**ADDENDUM NO. 4**

Date: September 14, 2018  
Project: **Secondary Treatment Plant Upgrade & Recycled Water Expansion**  
Job No.: 12600-07/16650-02

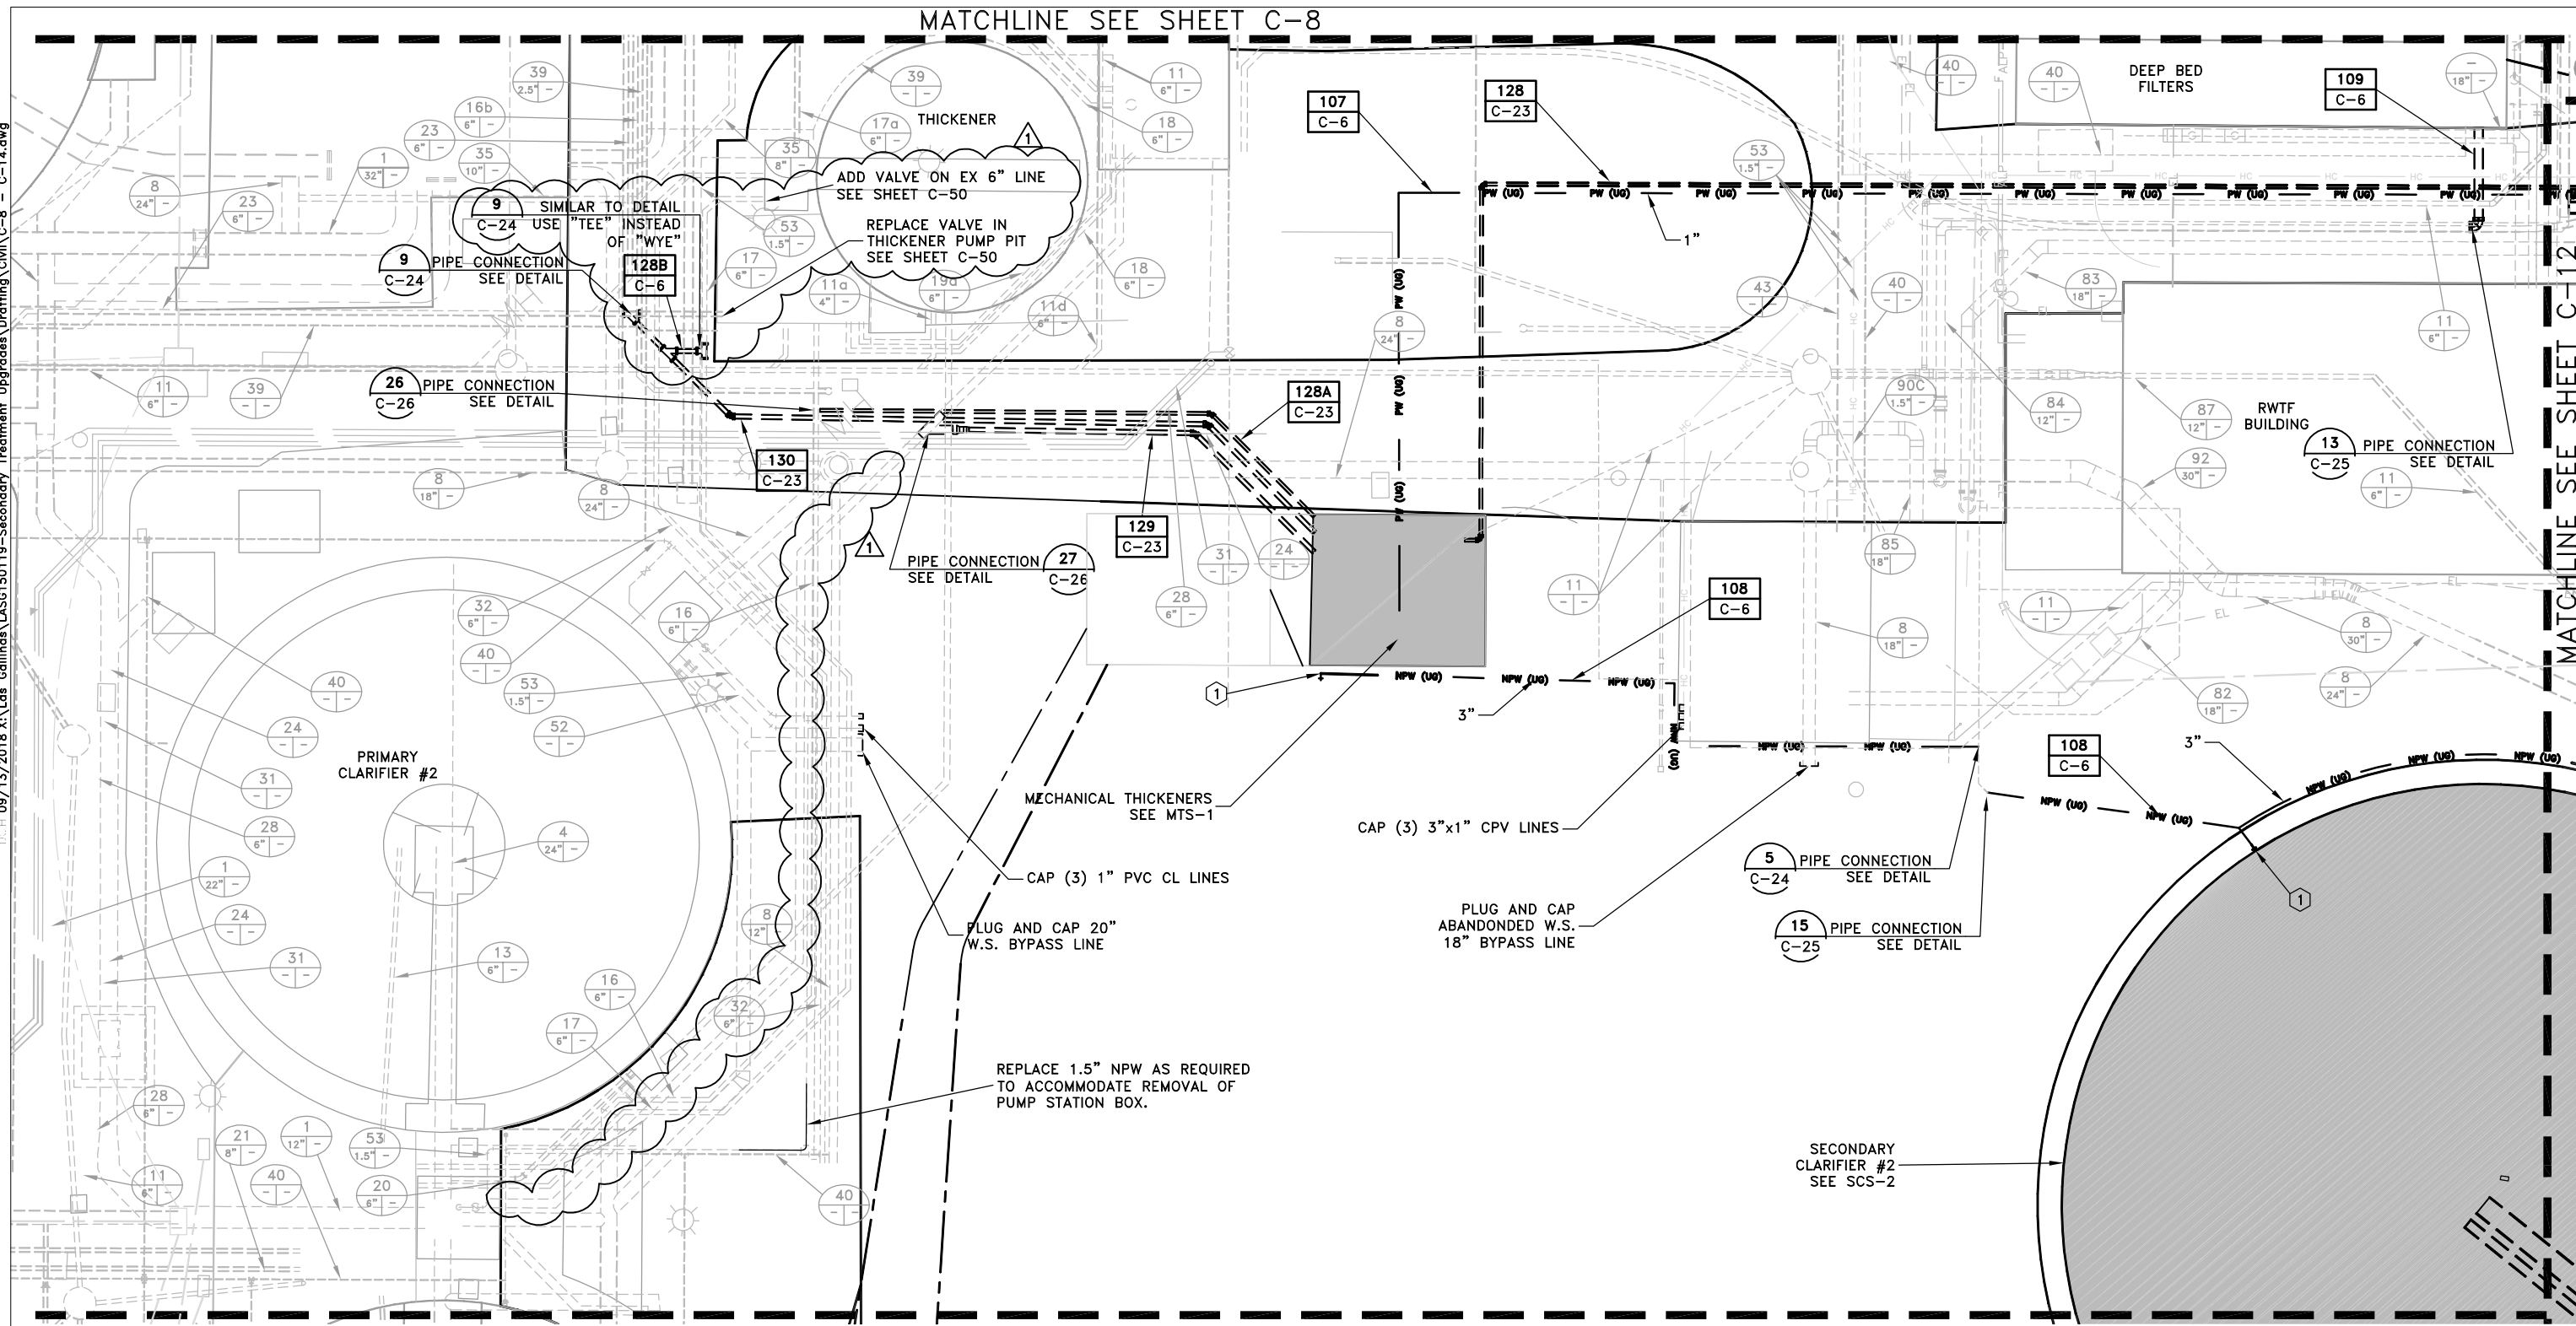
2. **Sheet C-5:** The southern portion of paving along the hillside (where new asphalt is planned) currently has a block wall along the road and hill. The District has elected to preserve and maintain this block wall rather than installing Type 'E' curb along the asphalt as currently indicated on sheet C-5. Thus, curbing is no longer required along this portion of the pavement and the Contractor is just to preserve and protect the existing wall. **A copy of Sheet C-5 is provided with this addendum** indicating which segment of curbing has been removed from the work.

**The block retaining wall should be protected and remain in place during construction. The Type E curbing is no longer required along this portion, refer to the description for sheet C-5 above in the Volume 4A items.**

ROUTING HAS BEEN UPDATED FOR THE FOLLOWING LINES:  
 #116 (SC#2 RAS)  
 #126 (SC#2 SCUM)  
 #132B (STORM DRAIN)  
 #125 (SC#1 SCUM)

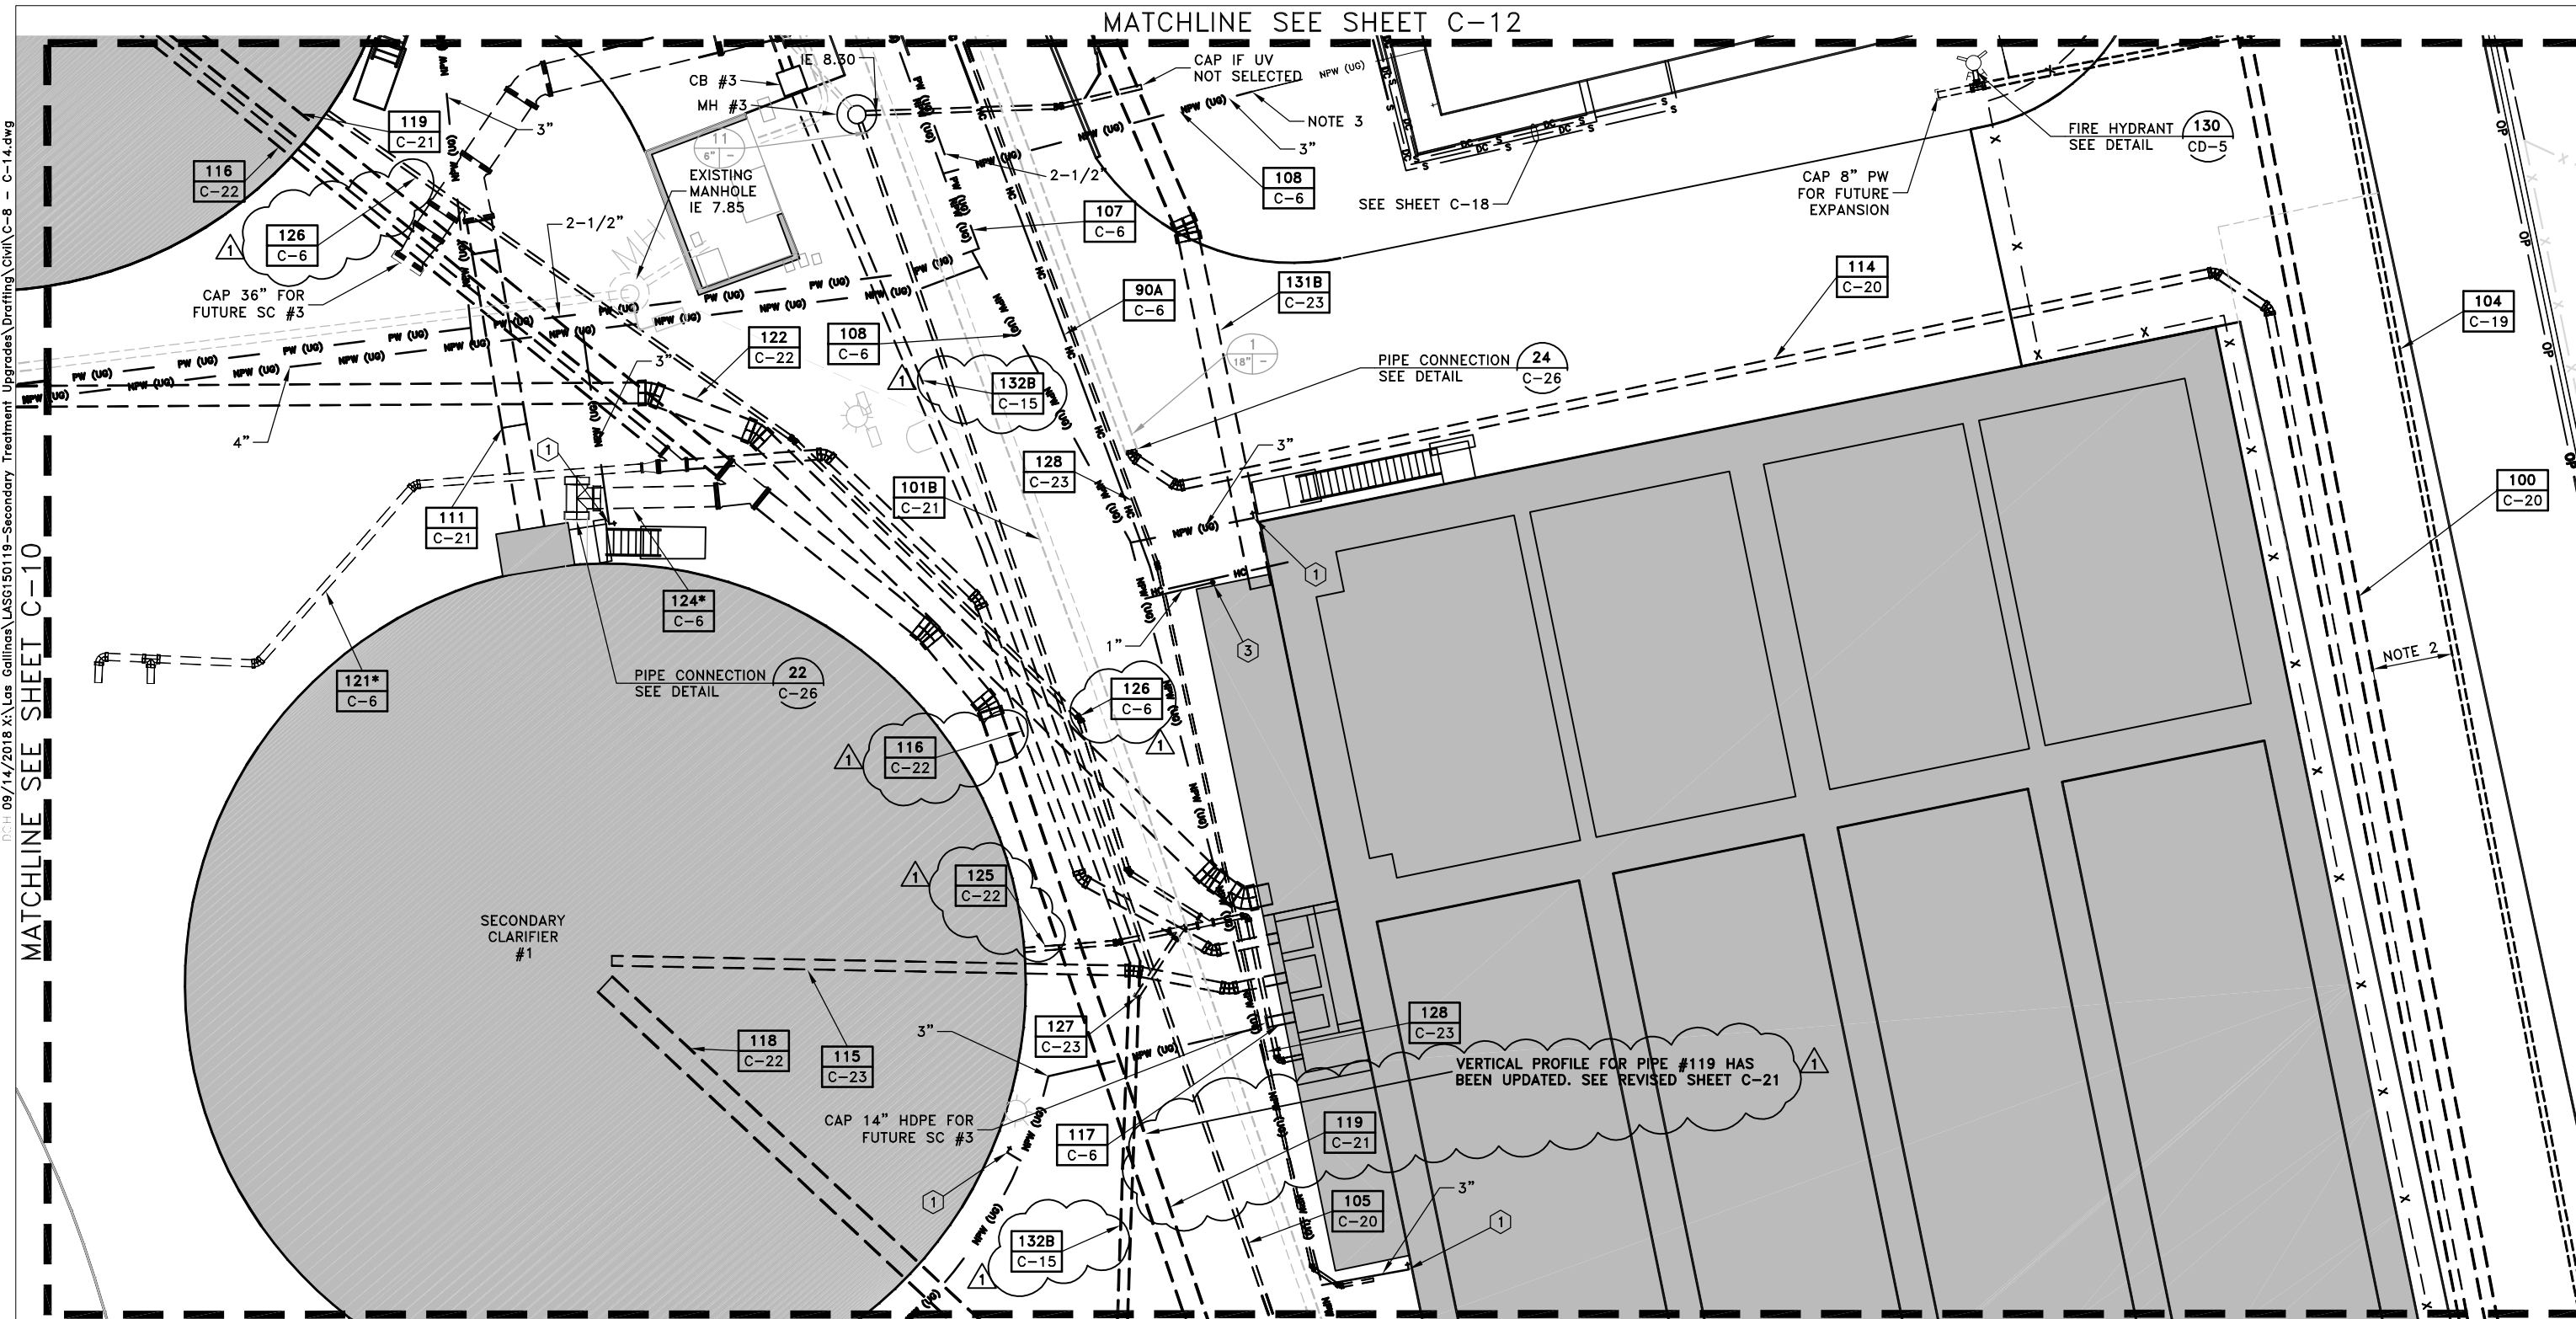
4. **Sheet C-13:** The routing of some pipelines has been adjusted to provide more space between pipelines that will be installed in Phase 1 (and 2) and the secondary clarifier #1 structure that cannot be installed until Phase 3. The updates are summarized as follows:

- b. Pipe #119 (30" secondary clarifier influent line) has the same plan view route, but the vertical profile has been adjusted to maintain this pipe beneath the drain field. See comments for Sheet C-21 for details.

<b>CIVIL YARD PIPING PROFILES</b>	
WBS <b>130</b>	CHECKED JRL APPROVED JRL GENERAL MANAGER Chris DeGabriele
DRAWN DCH DESIGNED EES DISTRICT ENGINEER Michael P Cortez	SCALE AS SHOWN DATE 07/26/18
SHEET 1	REVISIONS NO. DATE DESCRIPTION BY APPR'D 1 9/13/18 DRAWING HAS BEEN REVISED DCH EES

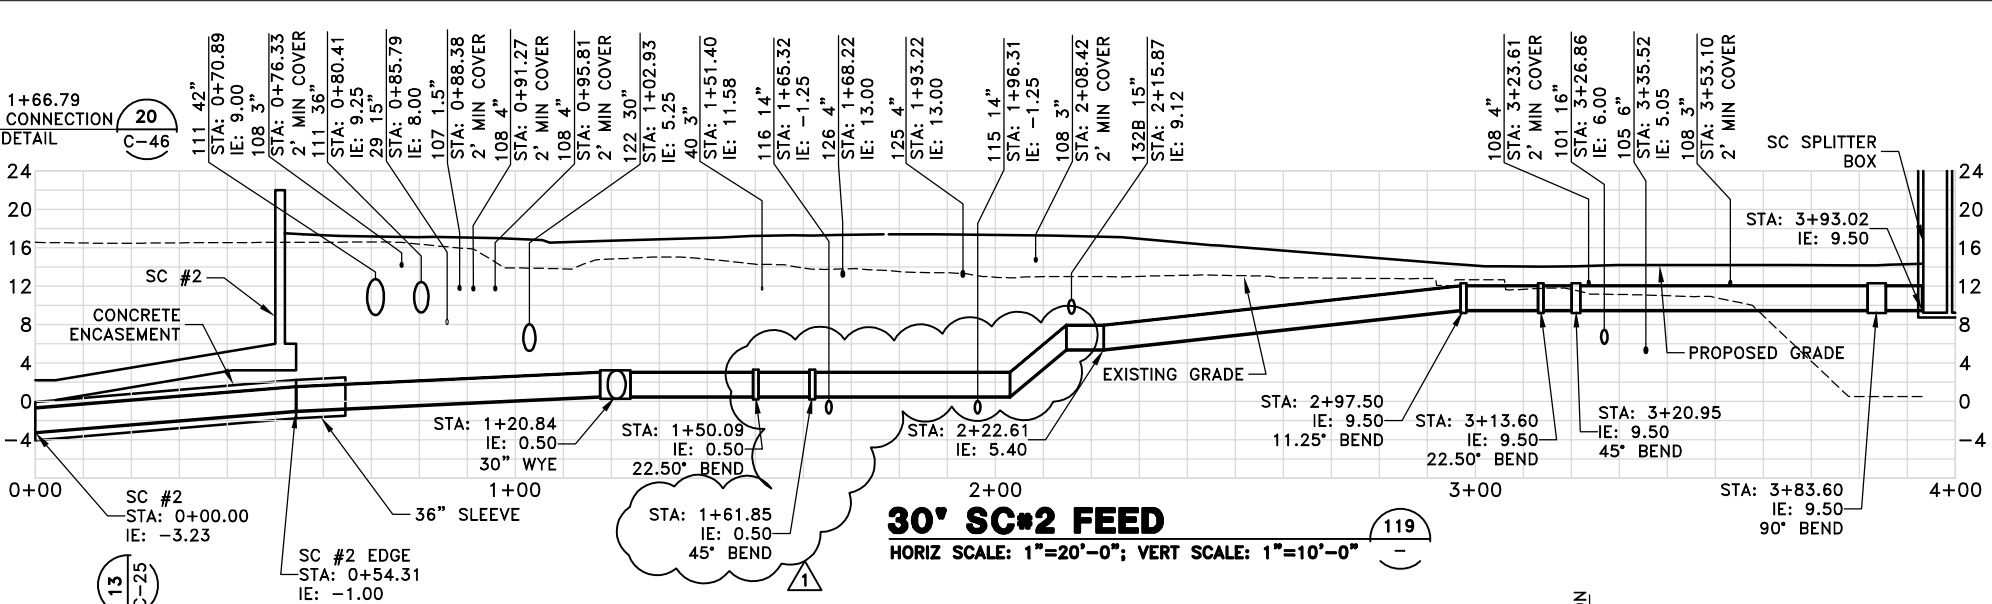
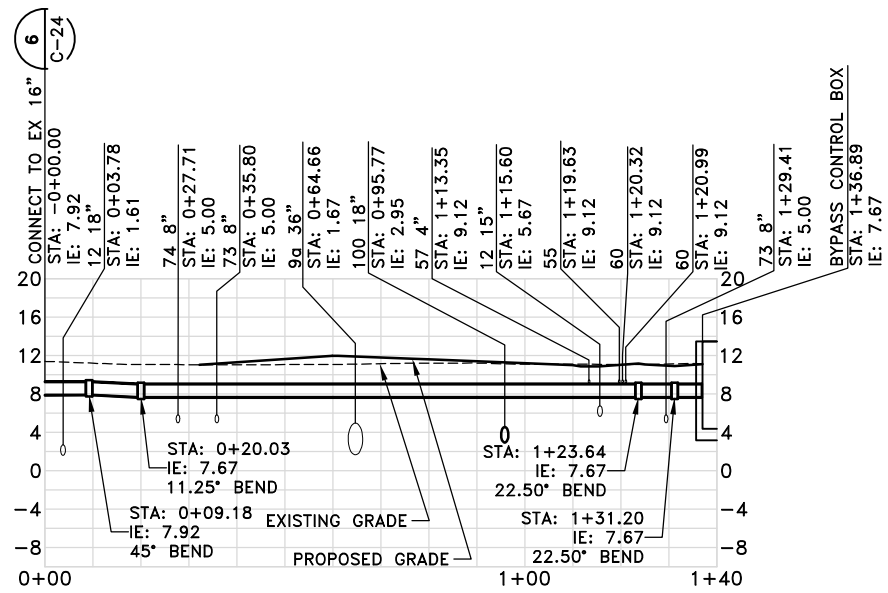
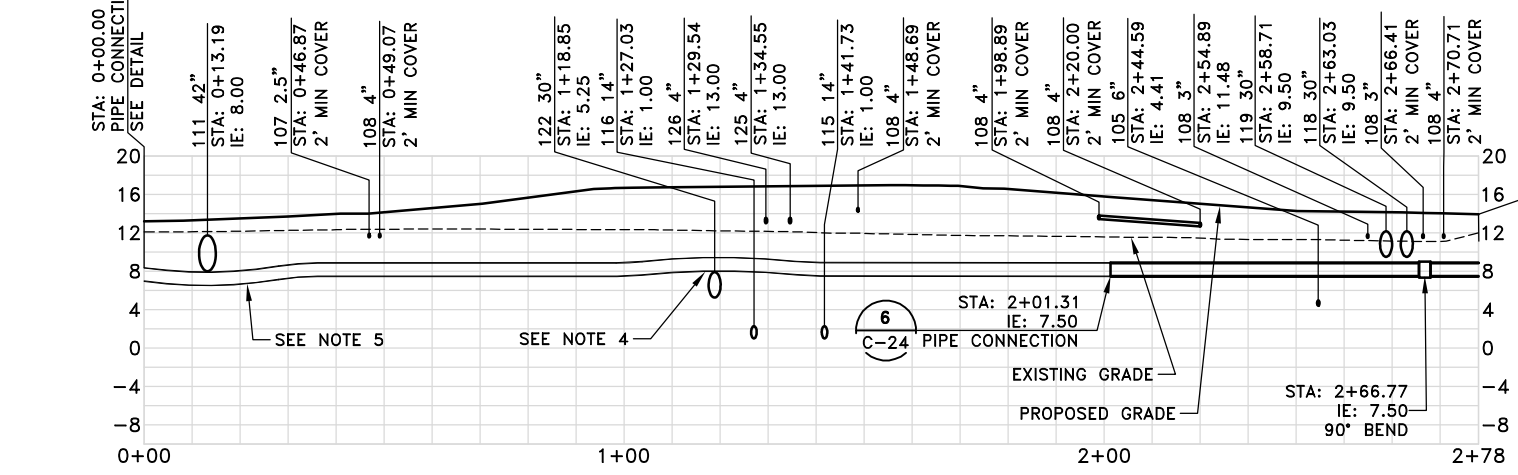
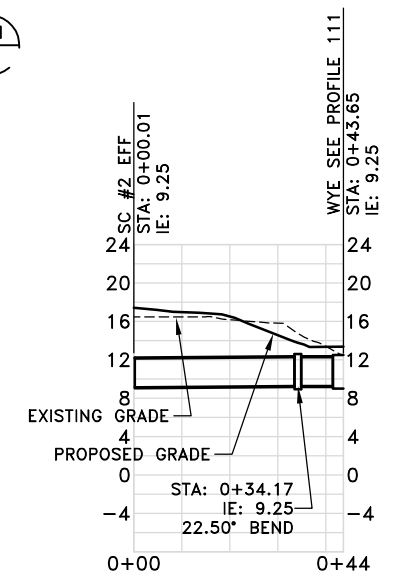
5. **Sheet C-21:** The profile for Pipe #119 (30" secondary clarifier #2 influent line) has been updated to maintain this pipe beneath footing and drain field improvements that will need to be installed after Pipe #119 is already installed and operational. **A revised version of this sheet is provided with this addendum.**
